To: Hamilton County Drainage Board

Re: Pebble Brook Drain – North Reconstruction

Re: Proposed Notice of Assessment for replacement of culvert pipes under
Pebblebrook Place in the Pebblebrook drain

RE: Pebble Brook Drain, North Reconstruction

Figure 3-5 Pebblebrook Place Road Profile

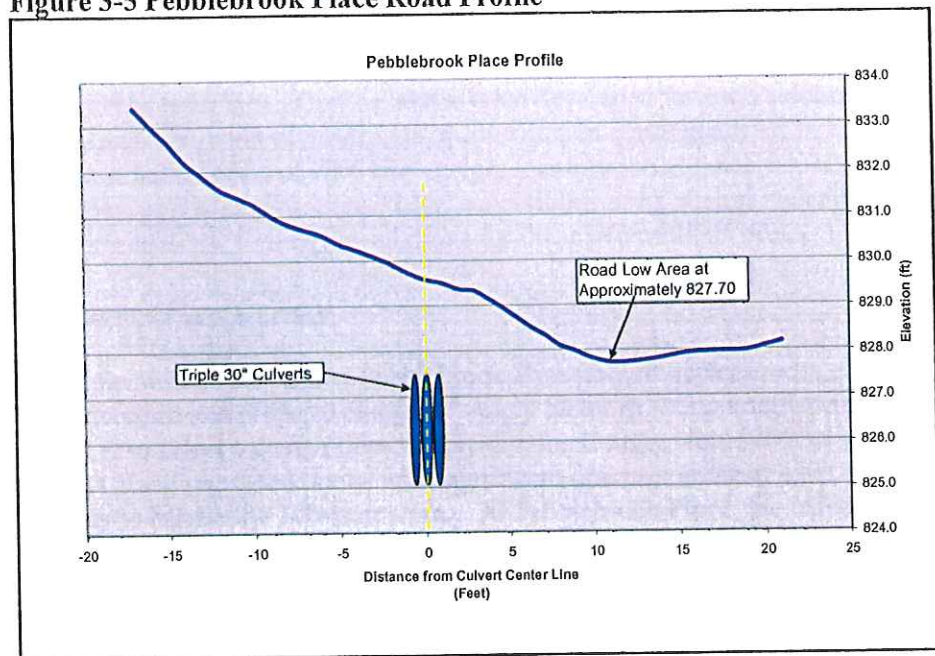
As seen above in the photographs, another problem is the profile of the roadway. Water overtops the road east of the culverts since the elevation of the roadway is considerably lower. The low spot in the roadway is approximately at the same elevation as the crown of the triple 30-inch culverts and allows very little surcharging of the culverts prior to roadway overtopping. A larger culvert replacing the existing at the same inverts would increase the crest elevation of the pipe. Figure 3-5 shows the roadway profile at the culvert

crossing of Pebblebrook Place. The culverts are centered at the zero-foot mark on the horizontal axis with an approximate invert of 825.1 feet.

Due to construction of upstream detention ponds, peak flows will decrease as the watershed is developed with the County's detention policy. However, even with the reduction in flow at the full buildout with detention scenario, the triple 30-inch culverts would still have less than 10-year capacity. The triple culvert barrel configuration is also prone to clogging with debris, which further reduces capacity.

Figure 3-6 HY8 performance curve of the proposed 12 foot by 4 foot culvert

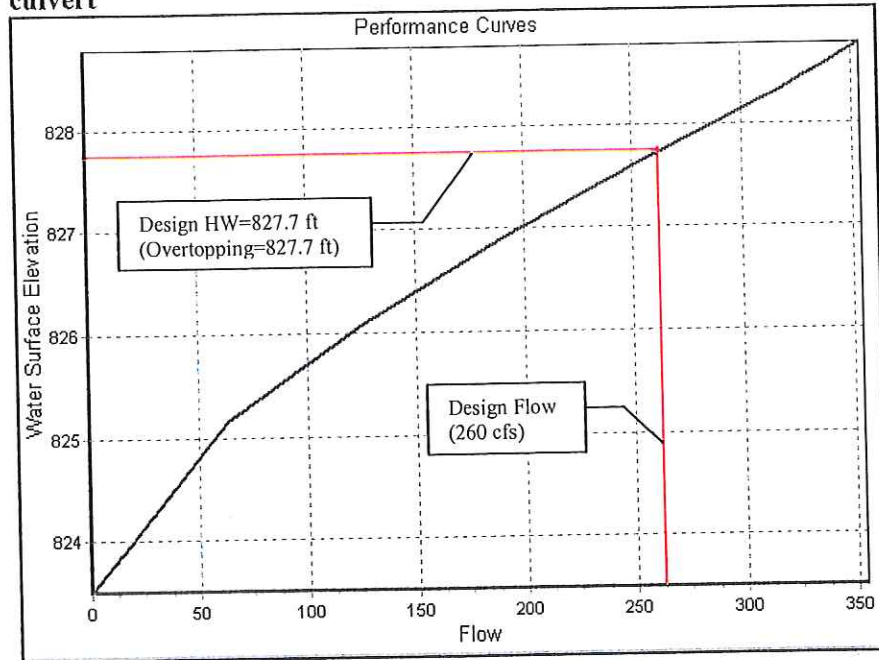
Box culverts were analyzed using the HY8 program to determine the culvert size necessary for a design flow of 260 cfs. The analysis found a 12-foot wide by 4-foot high concrete box culvert would be required to pass 260 cfs without roadway overtopping. Figure 3-6 illustrates the rating curve from HY8 showing the capacity of the proposed culvert.

Figure 3-7 Profile of the Pebblebrook Main Channel at Pebblebrook Place

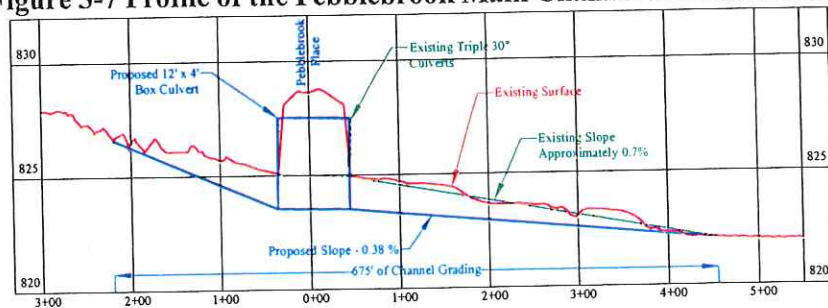
The proposed culvert has a higher rise than the existing 30-inch culverts and would need to be approximately 1.5 feet lower to fit under the roadway. To accomplish this, the channel would need to be re-graded and lowered upstream and downstream of the culvert. This is possible, as the slopes of the stream in the vicinity of Pebblebrook Place are fairly steep. Figure 3-7 illustrates the impact of the proposed culvert on the channel profile. The installation of the culvert, as proposed, should not require any significant changes to the Pebblebrook Place roadway profile.

As shown in the profile, 675 feet of channel grading would be required. The channel grading allows the 12-foot by 4-foot concrete box culvert to be set low enough to allow adequate cover for the culvert wall thickness and pavement cross section. Until the upstream watershed is fully developed with detention, the 12-foot by 4-foot box culvert will provide less than 100-year capacity. Under existing conditions, the new culvert will nearly pass a 10-year storm (276 cfs vs. 260 cfs). After the Andover development is in place, the culvert will nearly pass a 50-year storm (271 cfs vs. 260 cfs). Hence, this culvert will

**SANITARY SEWER
RELOCATION PLAN AND
PROFILE**

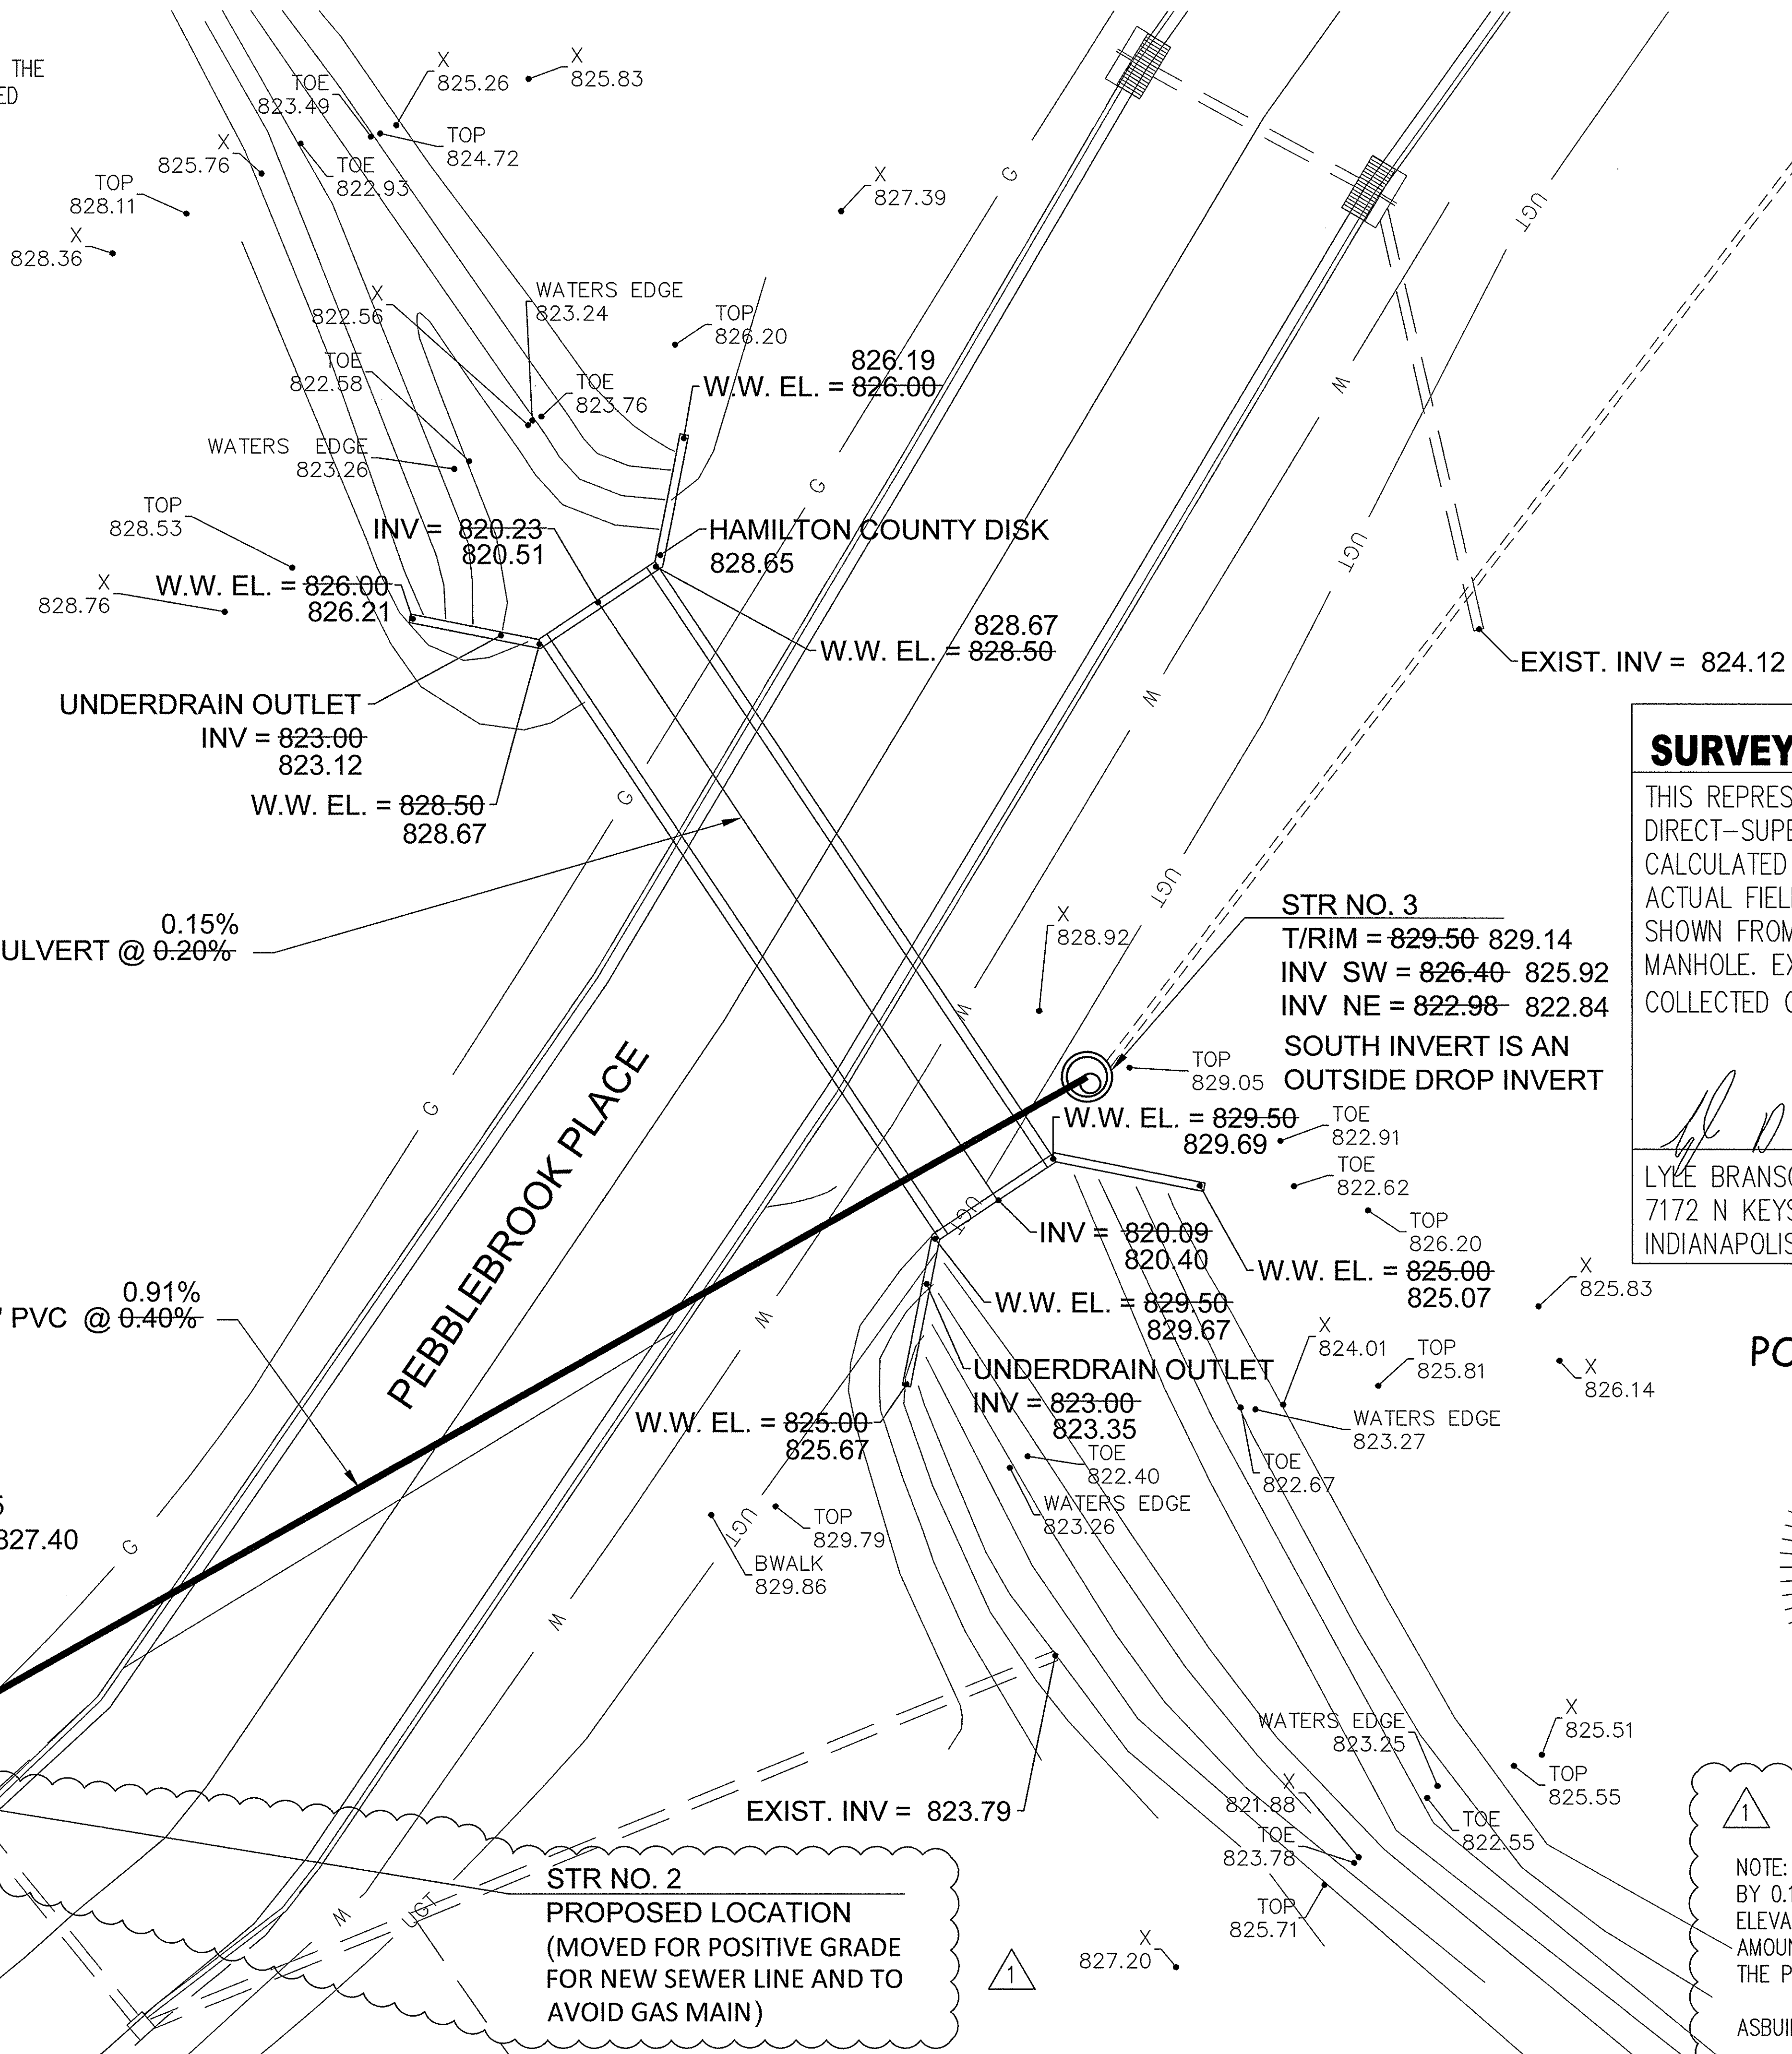
GENERAL NOTE: Designed location for STR 1 (Sanitary Manhole) had to be moved upstream because sanitary line would have conflicted with box culvert. The flow line elevation indicated on the plan was lower than actual elevation at STR 1 in field. The sewer had to be intercepted at an elevation so the sewer could clear over the new box culvert. The new sanitary main was higher than the lateral connections, so laterals had to be reran until grade was met. Per original plan, the lateral for 760 Pebble Brook was not thought to be affected, but moving STR 1 upstream made it part of the reconstruction area. Therefore the lateral to 760 Pebble Brook Place had to be replaced and 775 Pebble Brook Place went from a partial lateral replacement to a full lateral replacement because the new sewer was above the prior lateral grades. Reconstructed laterals were in established well-manicured front yards with irrigation systems which required full restoration. Reconstruction of the lateral required additional sidewalk and curbs needing repaired, as well as increased number of patches and area of patches.

1 ON 5/23/2014 ADDED A NOTE THAT EXPLAINS THE DATUM DIFFERENCE AND SHOWED THE PROPOSED LOCATION FOR STR NO 2.

NOTE: ASBUILT ELEVATIONS SHOWN HAVE BEEN RAISED BY 0.13 FEET FROM TBM 3006 DUE TO REVISED ELEVATION BROUGHT IN FROM STATION #104 HCSO. THE AMOUNT OF ERROR BETWEEN TBM 3004, PROVIDED ON THE PLANS, AND THE REVISED DATUM IS 0.21 FEET.

STR NO. 2
PROPOSED LOCATION
(MOVED FOR POSITIVE GRADE FOR NEW SEWER LINE AND TO AVOID GAS MAIN)
